RPRC RETURN LETTER

Application Number: 2021-0721

Street Location: 9 Quaker Meeting House Road

RE: Lazar Residence – 9 Quaker Meeting House Road – TaxID: 108.03-1-18

CONSTRUCTION DETAILS

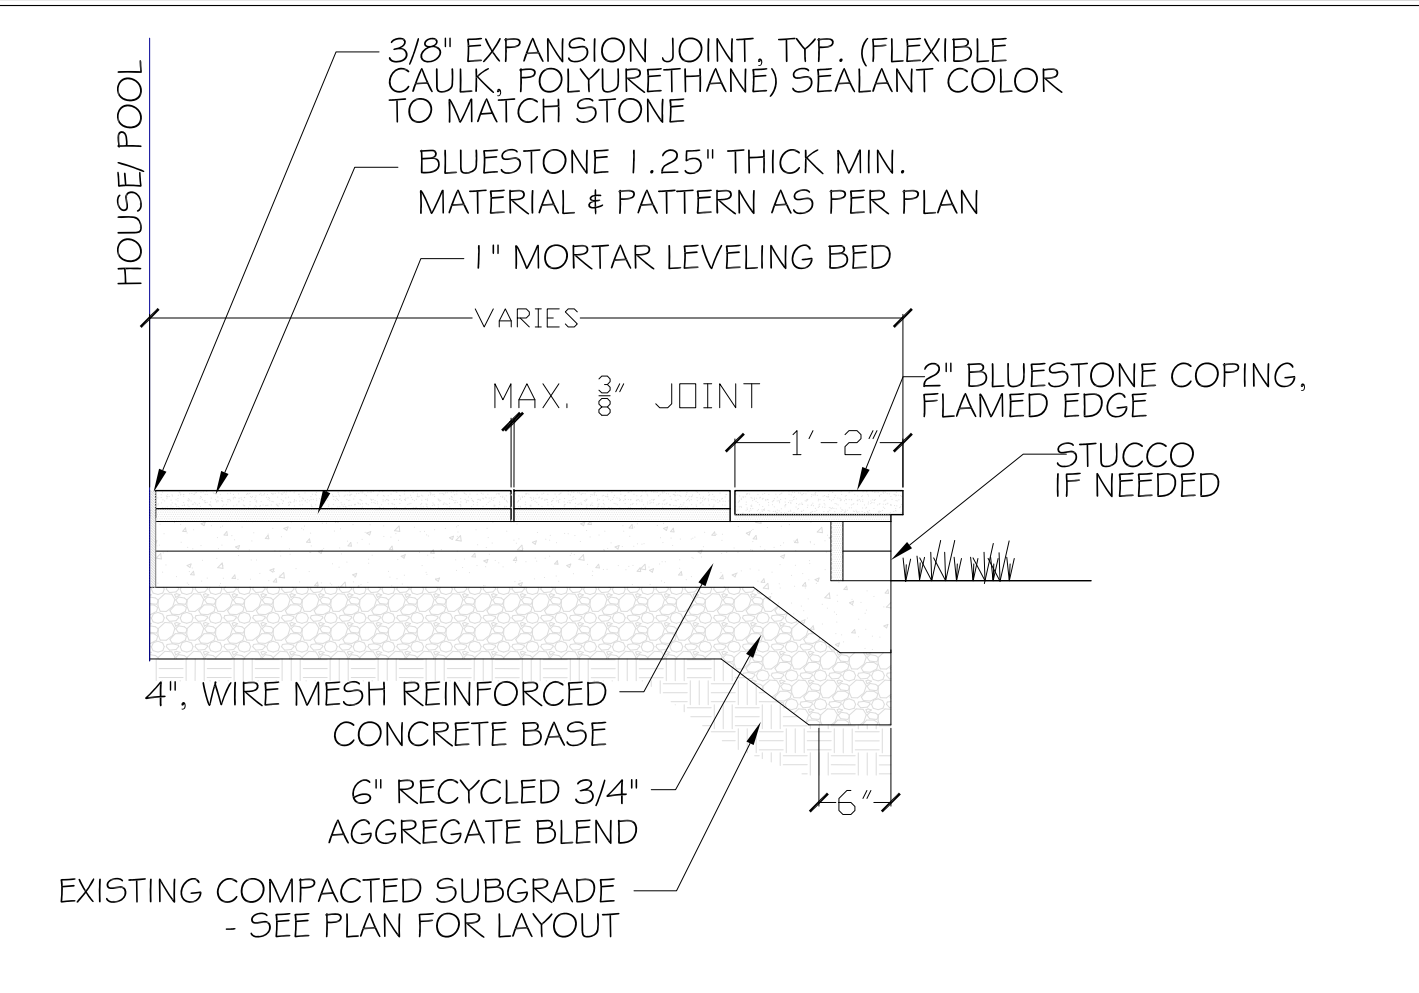
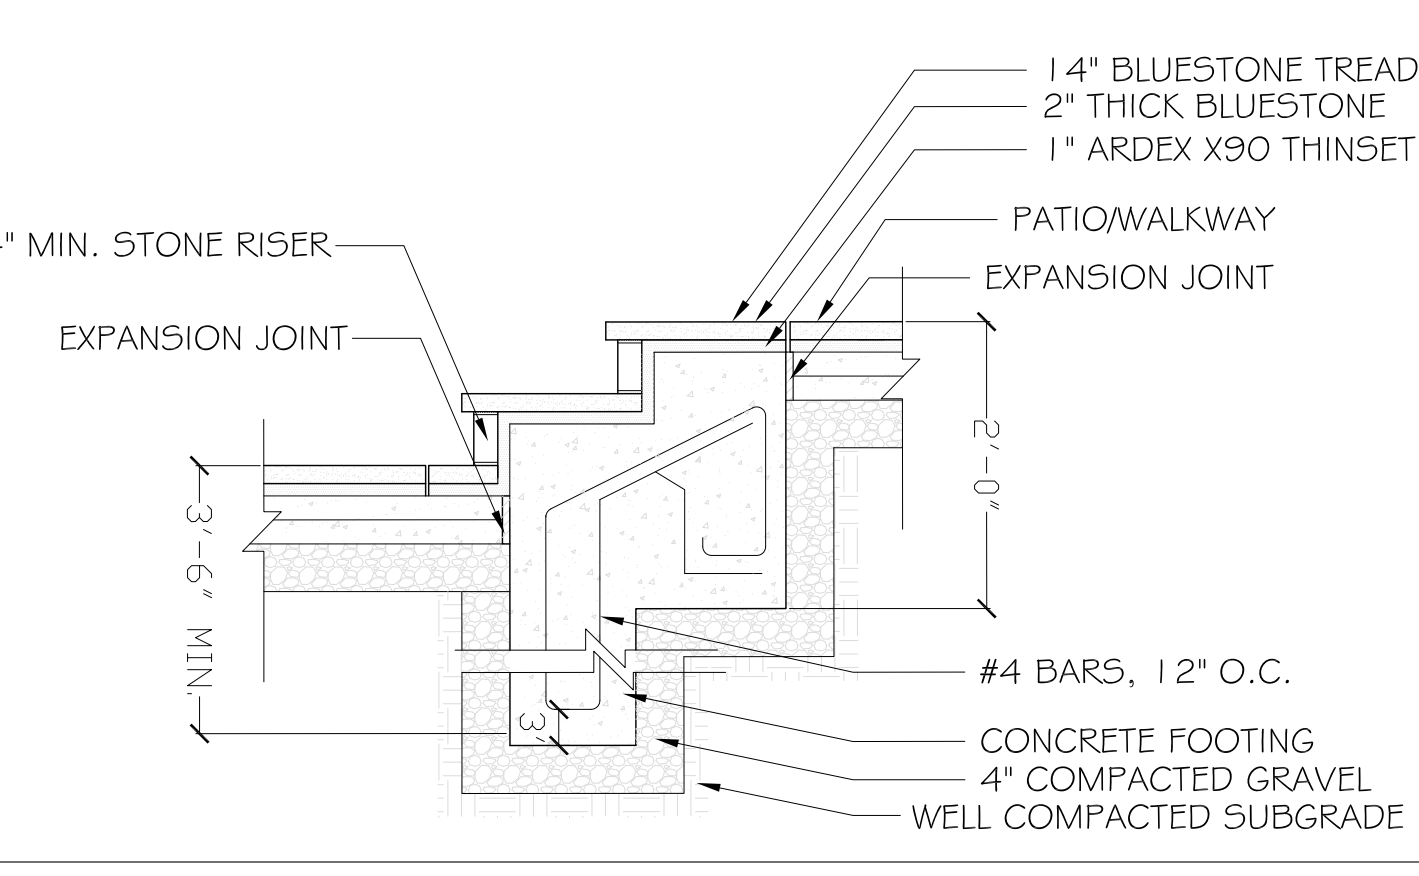
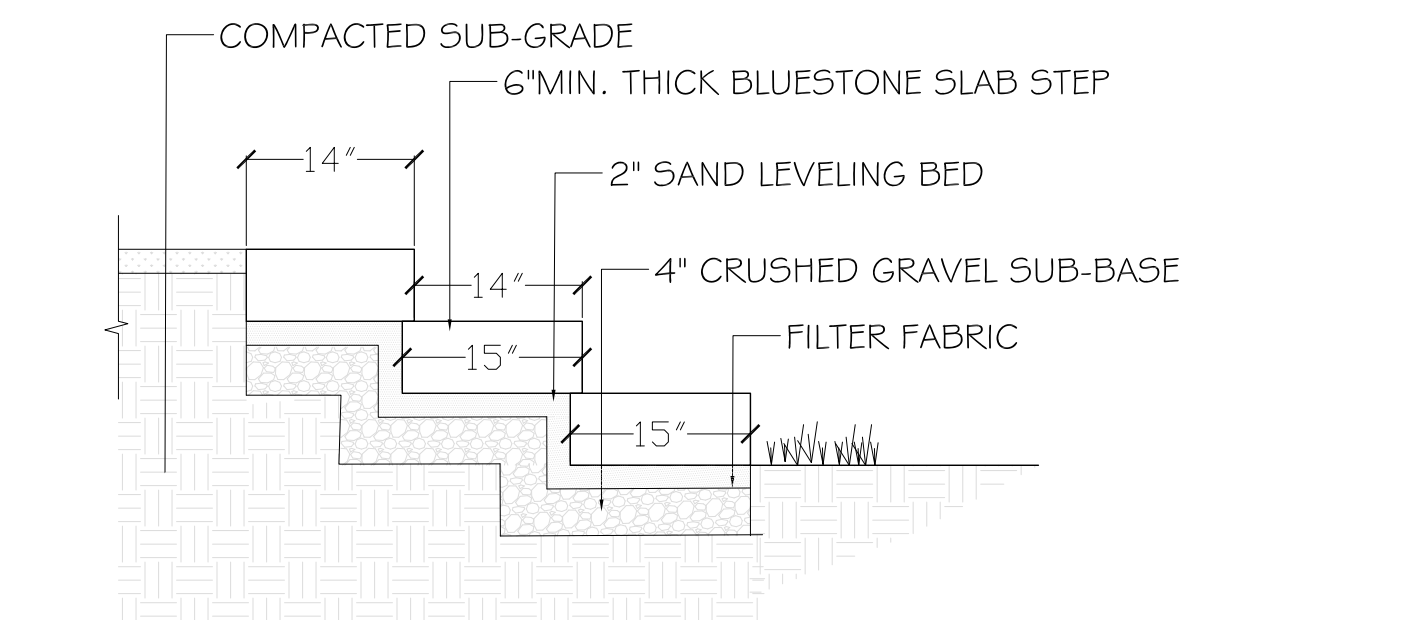
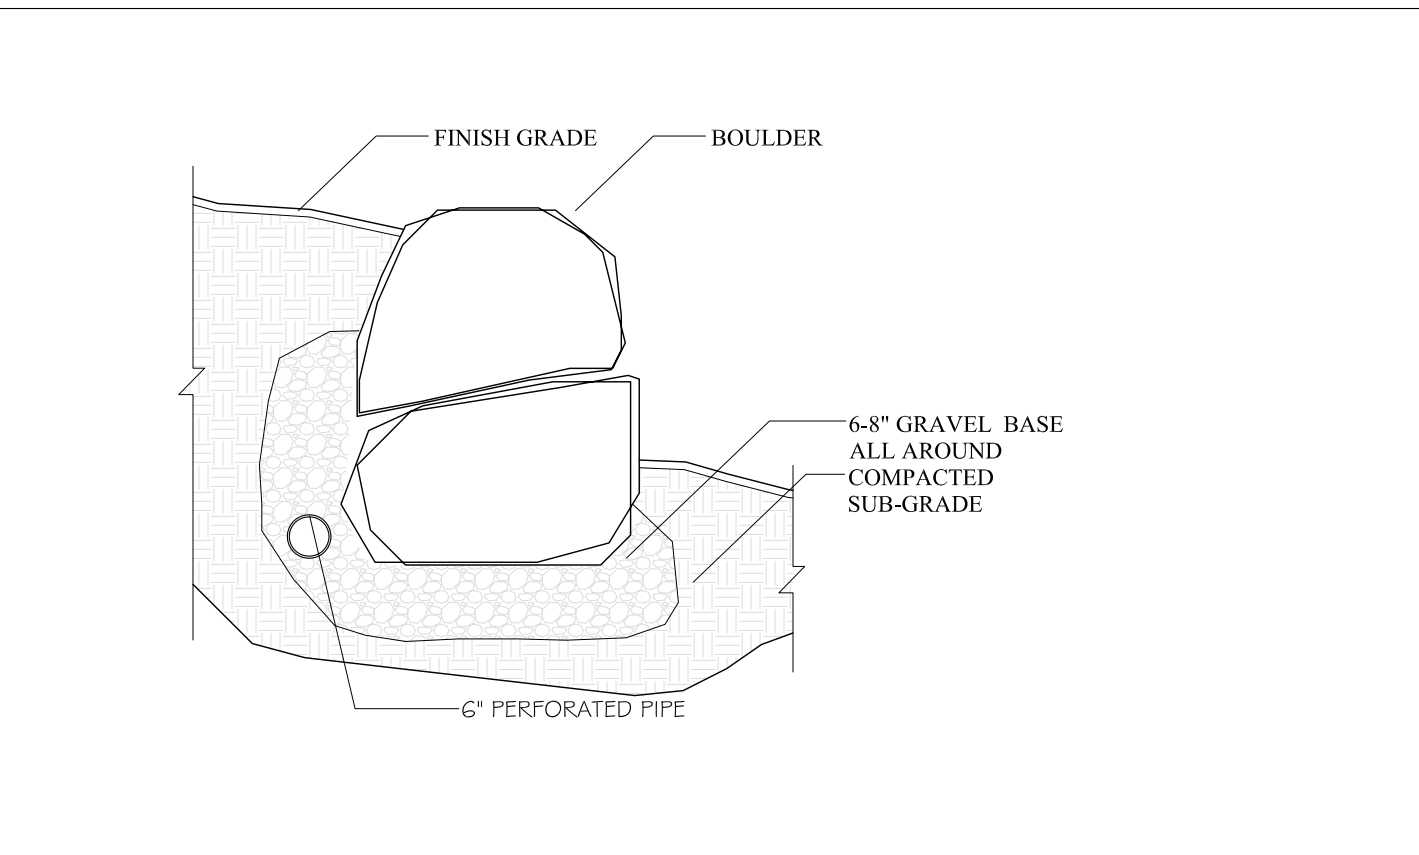
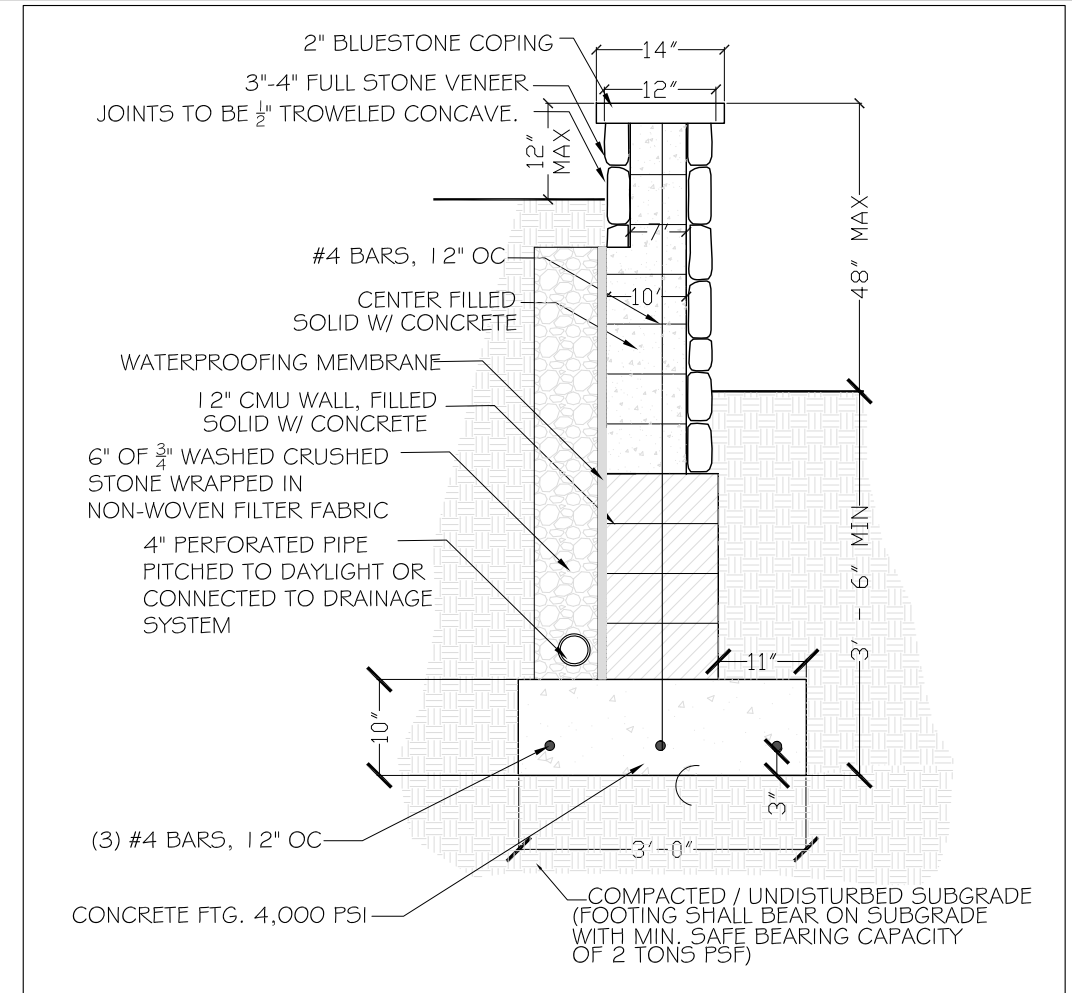
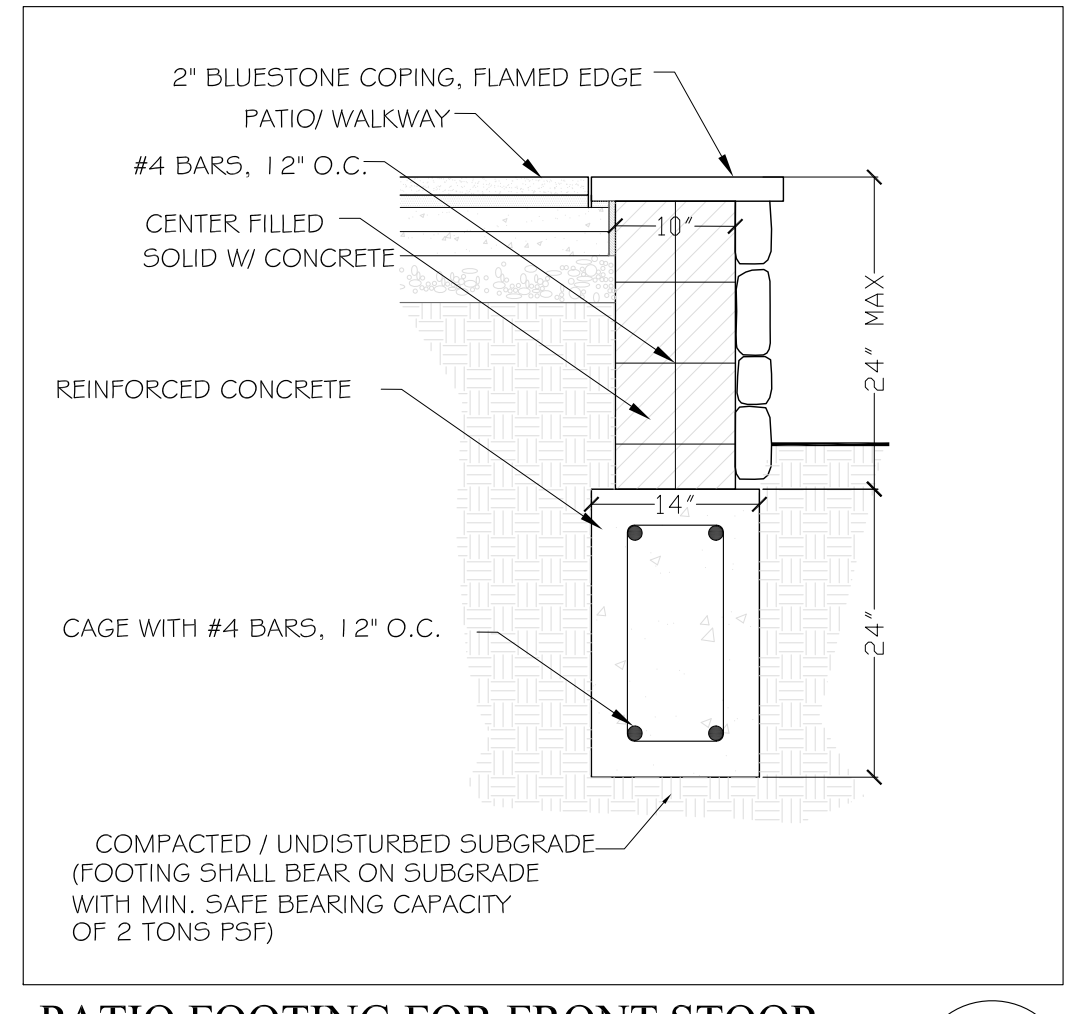
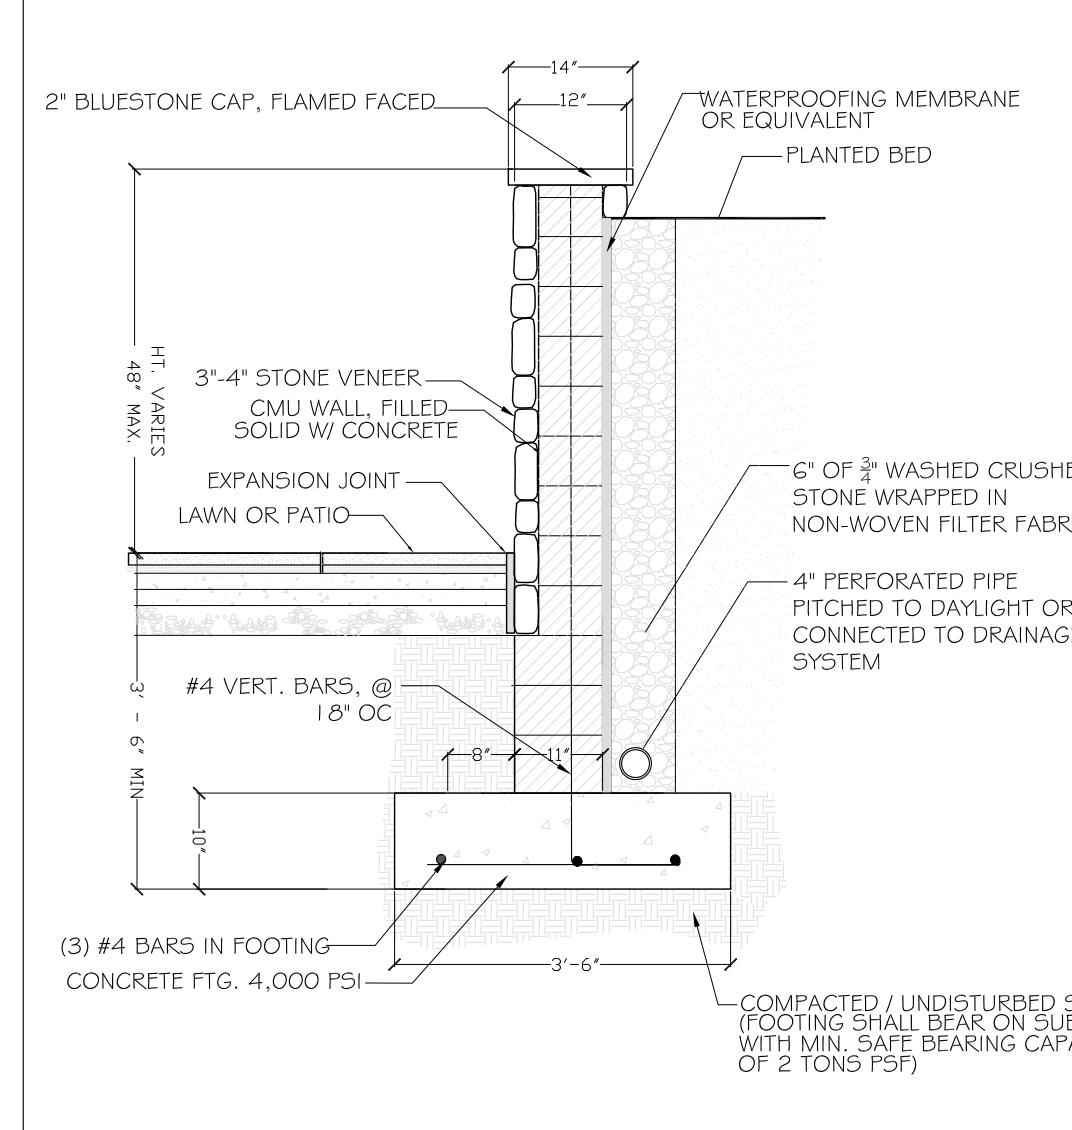
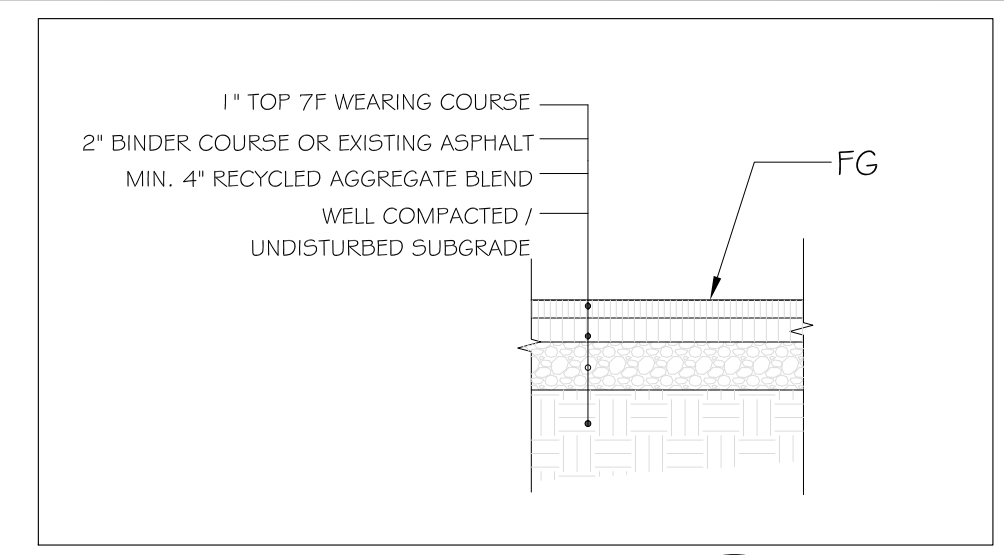
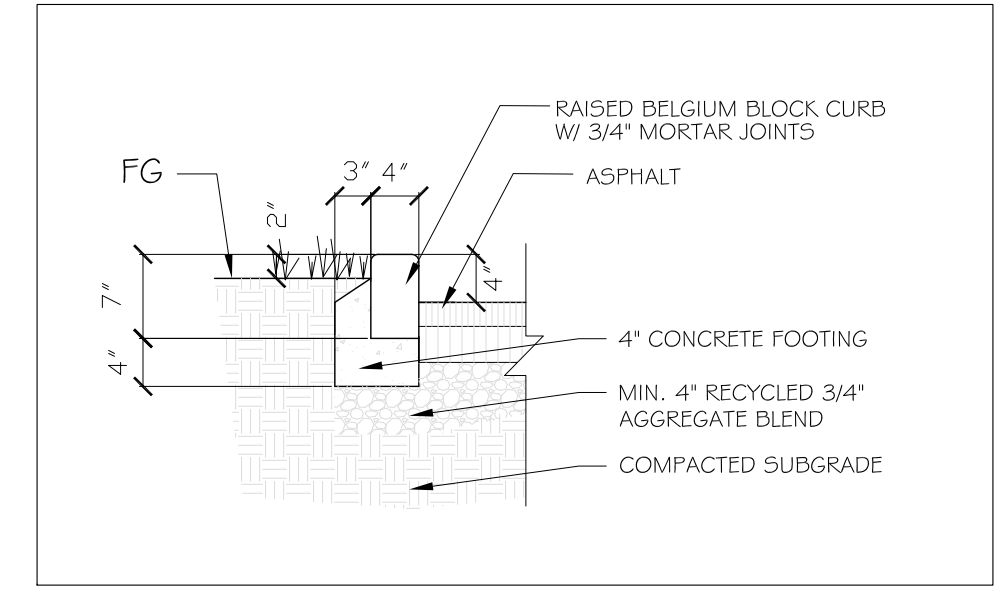
- The project plans should include drains and piping required to collect the runoff and discharge to the stormwater treatment system.
- The plans should provide construction details for the drainage system, retaining walls, patio, decorative driveway bands.

9. The plans should provide construction details for the drainage system, retaining walls, patio, decorative driveway bands.

Response: All construction details have been provided for the proposed work on sheet D-1. Drainage system details have been provided on engineering plans by Ahneman Kirby, LLC.
